ADDENDUM NUMBER 1
TO THE DRAWINGS AND SPECIFICATIONS

PROJECT: Lincoln Central Elementary School Bore Field

A/E PROJECT NO: 25821422A

SITE IMPACT PLAN
SCALE: 1" = 40'

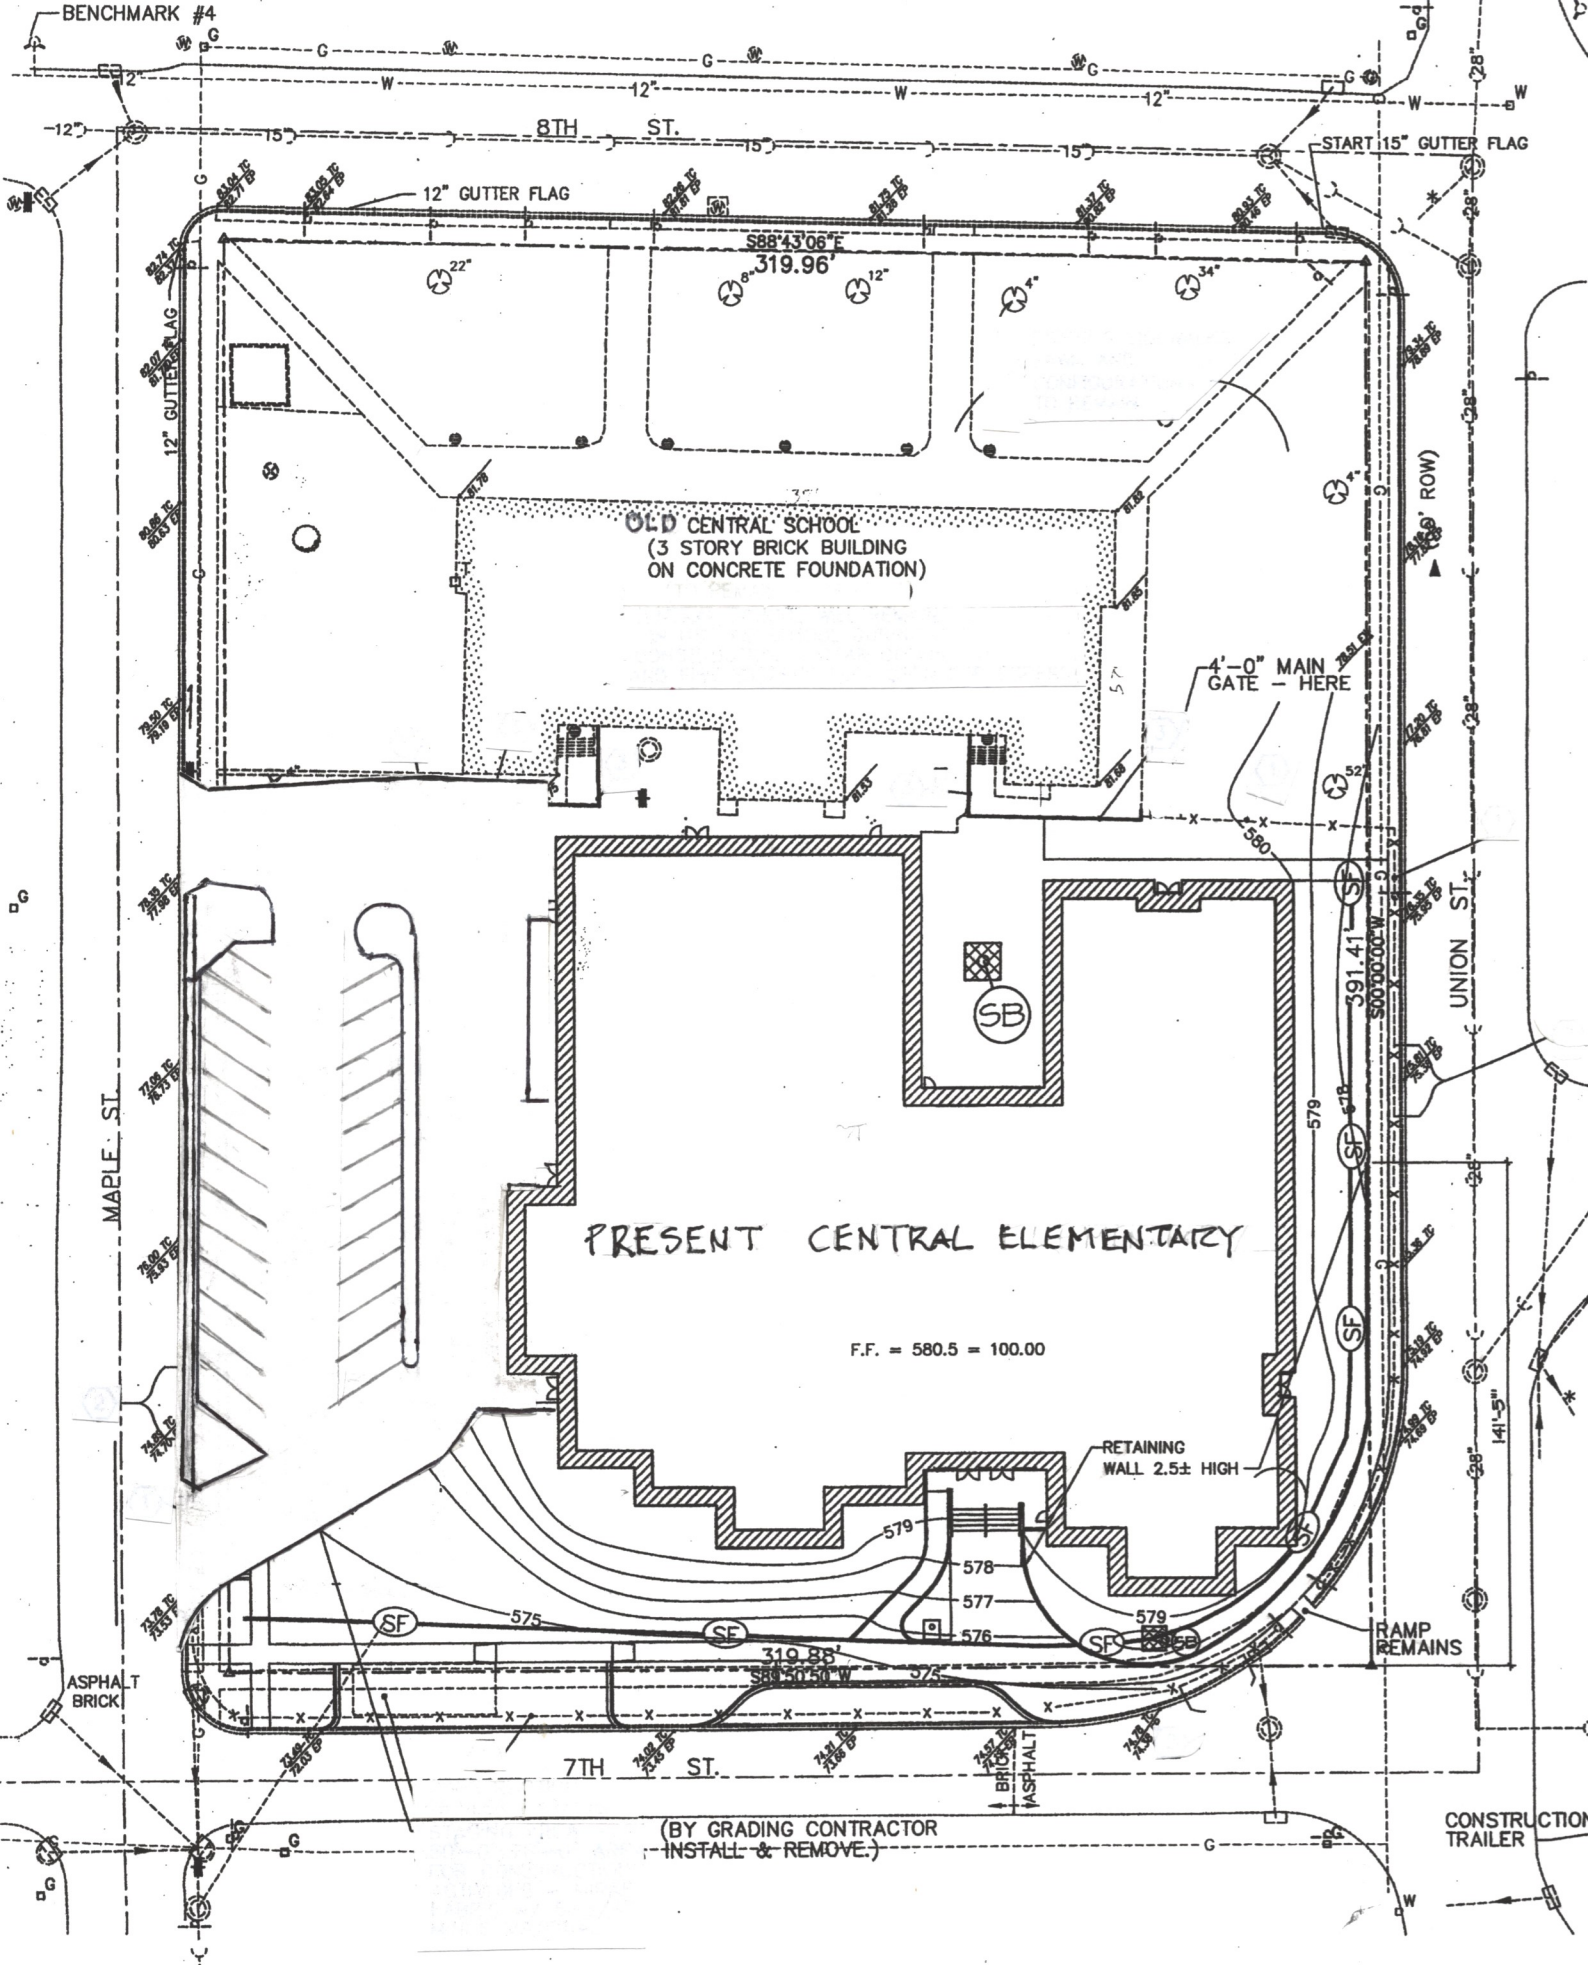
1. TO THE SPECIFICATIONS; Section 01 0100, Project Summary: Paragraph 1.1.B: To clarify this paragraph, a site plan showing the location of the present Central Elementary and the previous Elementary building built in 1887 and demolished in 2004 is attached. The demolition was not part of the new building construction and documentation of the demolition extent is not fully known. Persons who were interested in the demolition process 19 years ago indicate that it was intended to be a complete removal of existing footings, foundation walls, basement floor slab, and building utilities.
